Service Bulletin

Bulletin No.: PIC5657A

Subject: Condensation In Tail Lights Water In Trunk Or Spare Tire Well

Models: 2013 Chevrolet Malibu

Condition/Concern:

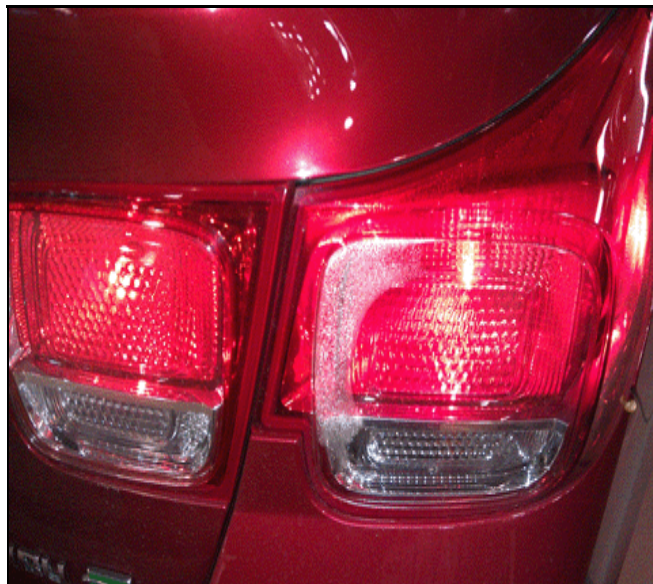
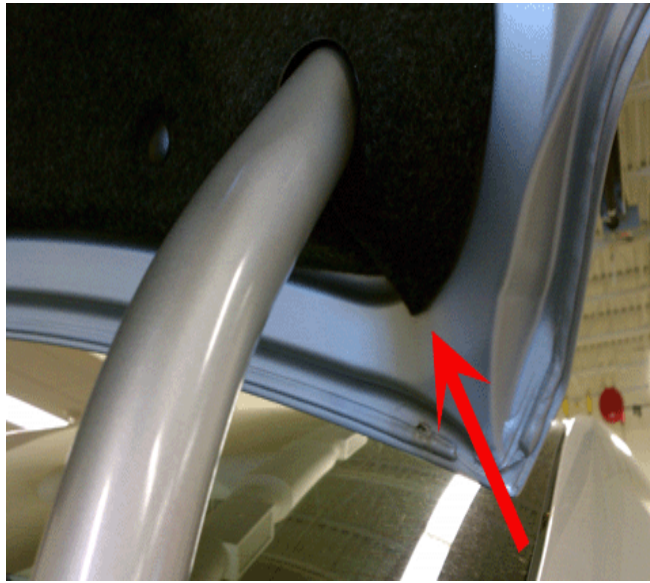
Condition: A customer or technician may indicate the tail lights have condensation in them, the trunk lining is wet or there is water in the spare tire well.

Cause: Mispositioned pressure relief valve, trunk lid liner, open seam or leaking wire harness retainer.

Correction: Check that both pressure relief valves are properly installed in openings. They should be snapped in from the outside. Check seam all around trunk opening and/or tail lamp pocket for skips in the sealer. Repair seams or reposition the pressure relief valve as needed. Check that the felt deck lid liner is not oversized and laying on the trunk opening seal when the trunk lid is closed. Check all wire harness retaining clips for signs of water intrusion and seal as needed. Clear tail light condensation by running the vehicle with park lamps on, this will by warm the lamps and clear the condensation. Photos below for reference.
